Model: Stella-C4	Date: 13-Jan-09	No.: RD067001
-------------------------	-----------------	---------------

Subject: Firmware Release Note: Engine(BICU-IC)		Prepared by: M. Ishihara	
From: 1st Tech. Support Sec. Service Support Dept.			
Classification:	<input type="checkbox"/> Troubleshooting	<input type="checkbox"/> Part information	<input type="checkbox"/> Action required
	<input type="checkbox"/> Mechanical	<input type="checkbox"/> Electrical	<input type="checkbox"/> Service manual revision
	<input type="checkbox"/> Paper path	<input type="checkbox"/> Transmit/receive	<input type="checkbox"/> Retrofit information
	<input type="checkbox"/> Product Safety	<input checked="" type="checkbox"/> Other ()	<input checked="" type="checkbox"/> Tier 2

This RTB has been issued to announce the firmware release information for the **Engine(BICU-IC)**

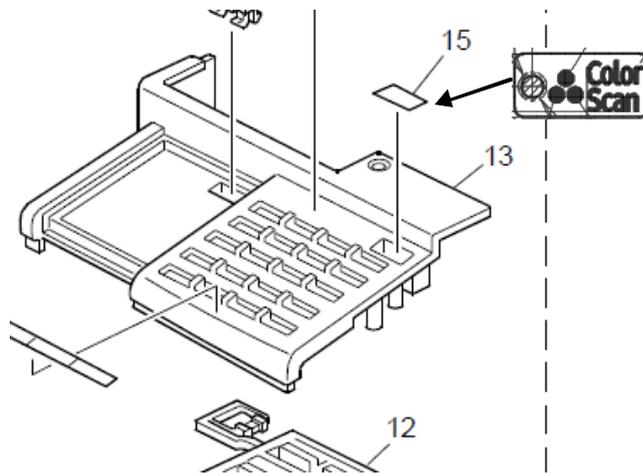
Old part number	New part number	Description	Q'ty	Int	Page	Index	Note
	B2621467	SHEET:DISPLAY:EXPAND:B:NA	1-1		11	15

Change/Reason: The "Color Scan" decal was missing from the parts catalog.

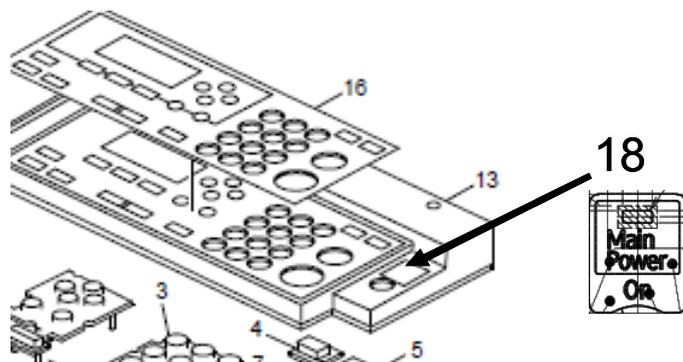
Old part number	New part number	Description	Q'ty	Int	Page	Index	Note
	B2621458	SHEET:DISPLAY:POWER SOURCE:NA	1-1		9	18

Change/Reason: The "Main Power On" decal was missing from the parts catalog.

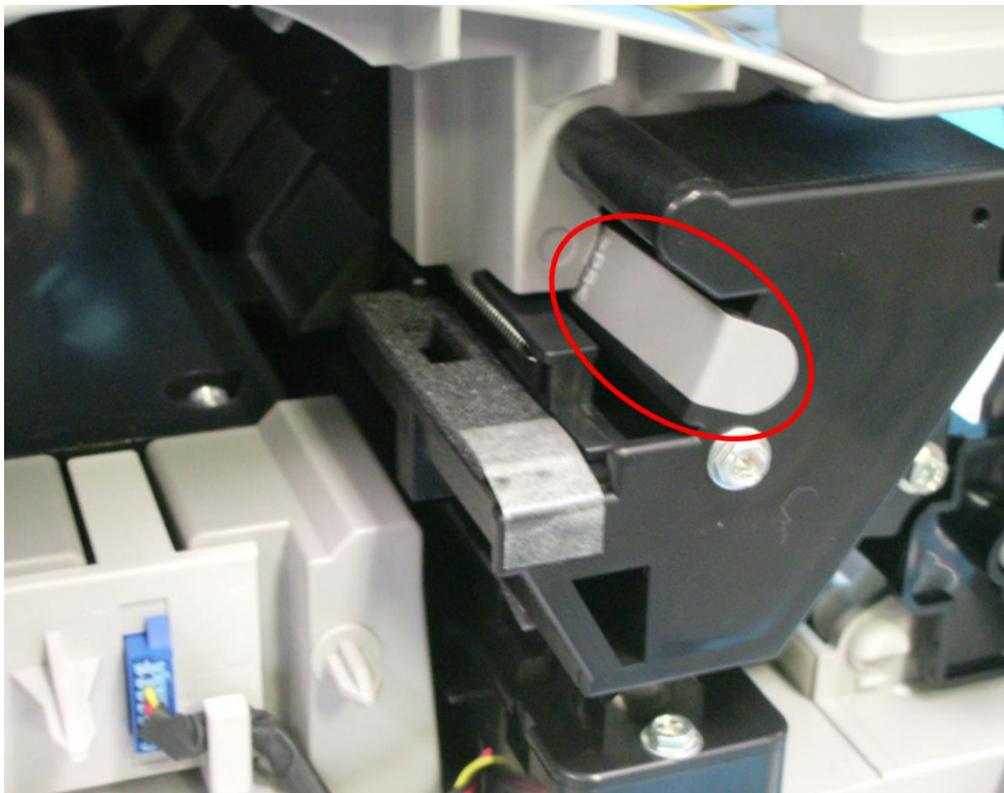
2. The seal affixed to the area circled in the photo was deleted.

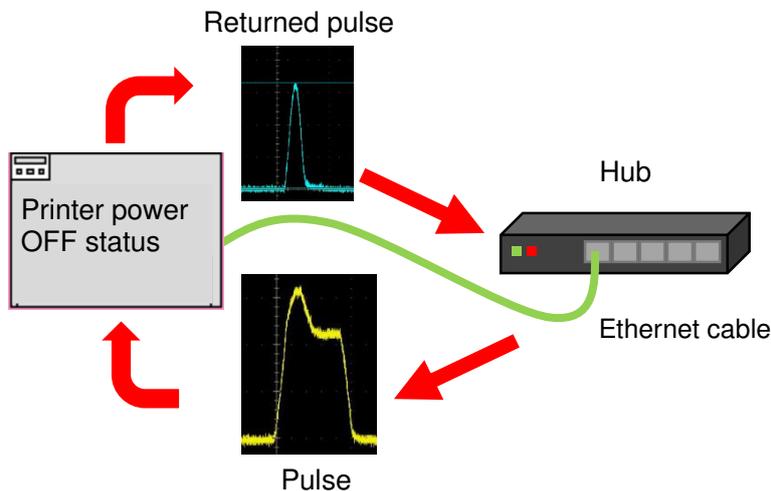
Old part number	New part number	Description	Q'ty	Int	Note
D0685713	D0685716	PCB:CTL:STL-C4:SUB-ASS'Y	1 - 1	X/O

Interference in network communication may occur, if the printer is connected to a hub and the printer switch had been turned OFF (or the power cable was unplugged).

The circuit on the Controller Board was modified.
